## **BROADWAY THREE NOTCH ROAD SUBDIVISION**

The plat illustrates the proposed 1-lot, 1.3± acre subdivision which is located on the North side of Three Notch Road, 185'± East of General Road, in Council District 4.

APPLICATION NUMBER 3 DATE January 17, 2019

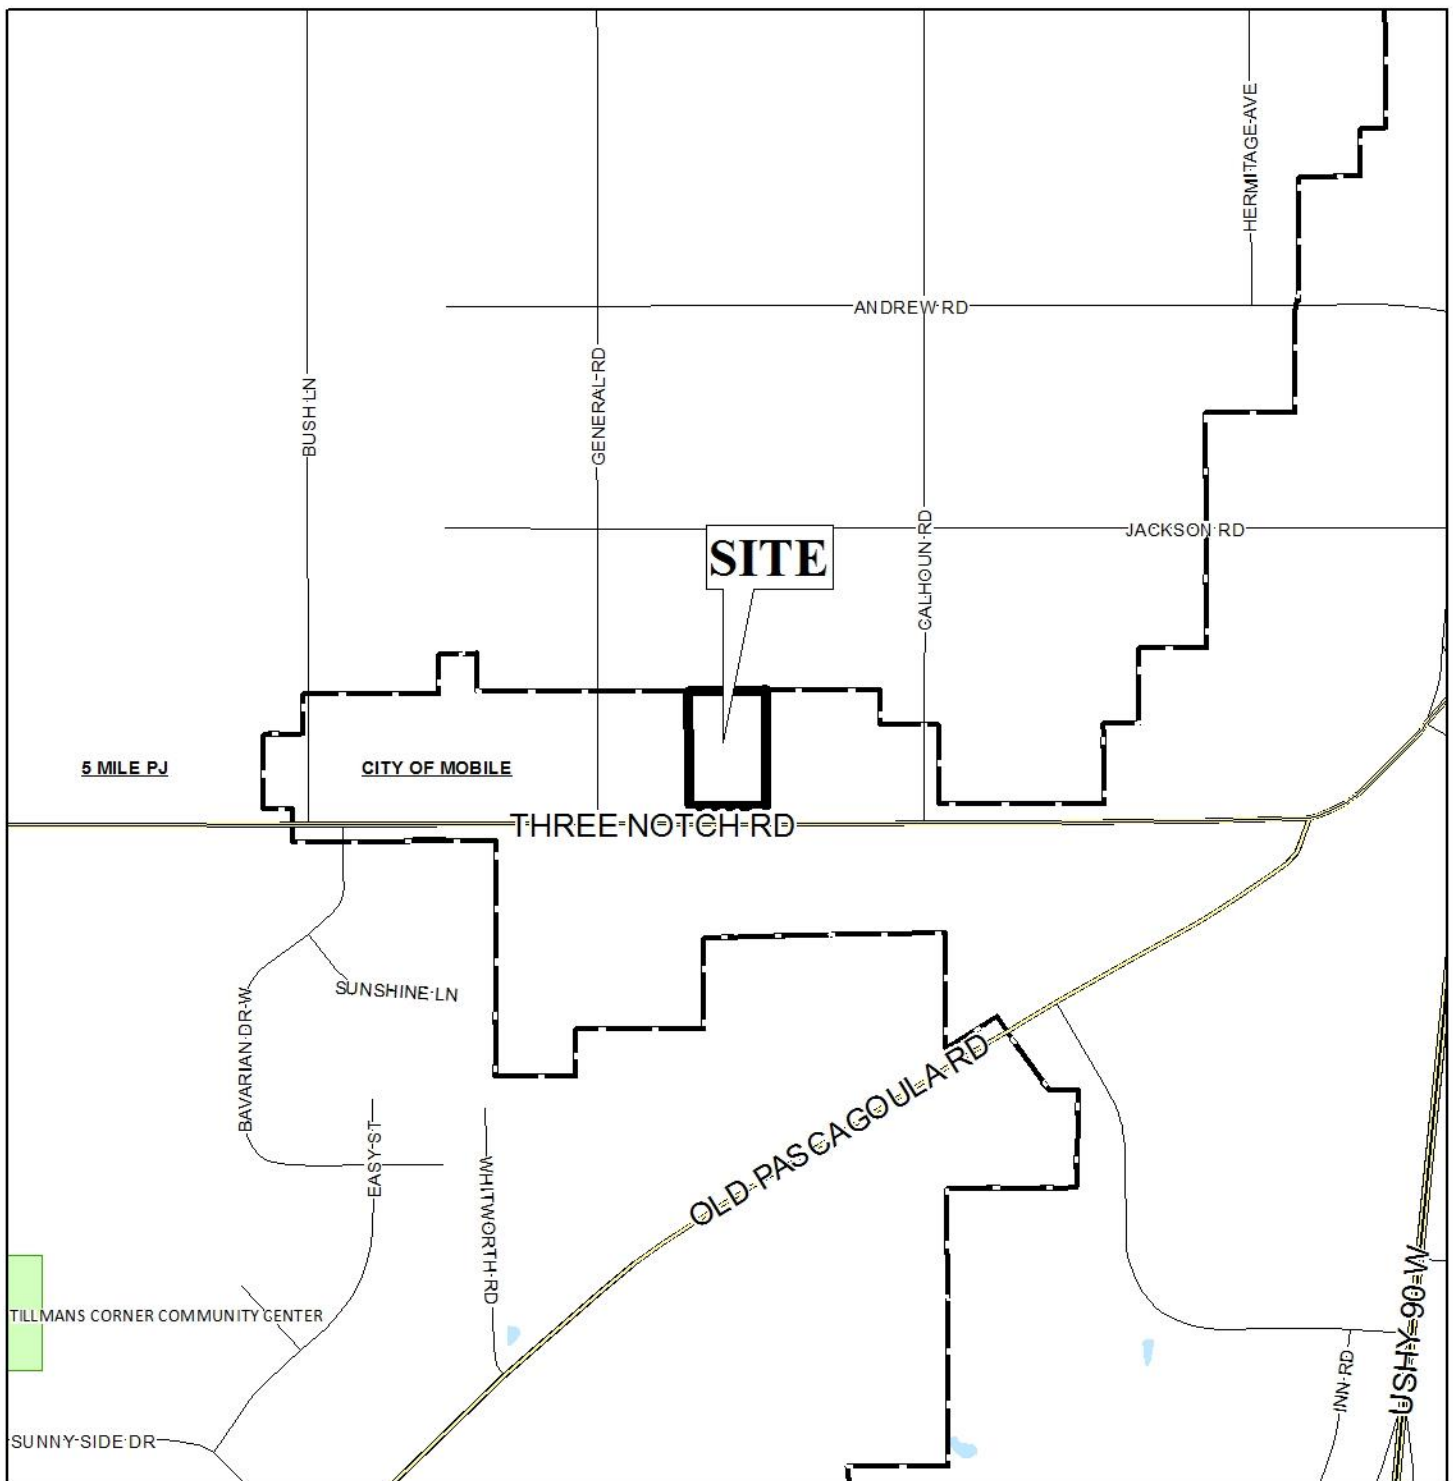
The site has frontage on Three Notch Road, a component of the Major Street Plan with a planned 100' right-of-way. The preliminary plat indicates the right-of-way width from the centerline of Three Notch Road to be slightly over 50'. Therefore, no dedication would be required along Three Notch Road. If approved, the current right-of-way width of Three Notch Road should be retained on the Final Plat. The 25' minimum building setback line is not indicated along Three Notch Road and the plat should be revised to indicate such on the Final Plat.

As on the preliminary plat, the lot size label should be retained in both square feet and acres on the Final Plat, or a table should be furnished on the Final Plat providing the same information. No easements are indicated on the preliminary plat. If any easements are recorded on the site they should be indicated and labeled on the Final Plat, and a note should be placed on the Final Plat stating that no structure may be placed or constructed within any easement.

The site is zoned B-3, Community Business, and contains various buildings on the two existing lots. All accessory structures should be removed via the proper demolition permits prior to signing the Final Plat for the subdivision so that only a single structure remains at maximum.

- 1) retention of the current right-of-way widths of Three Notch Road on the Final Plat;
- 2) revision of the plat to illustrate the 25' minimum building setback line along Three Notch Road;

- 3) retention of the lot size in both square feet and acres, or the furnishing of a table on the Final Plat providing the same information;
- 4) placement of a note on the Final Plat stating that no structure may be constructed or placed within any easement;

- 5) removal of all accessory structures on the site via the proper demolition permits prior to signing the Final Plat so that only a single structure remains at a maximum;
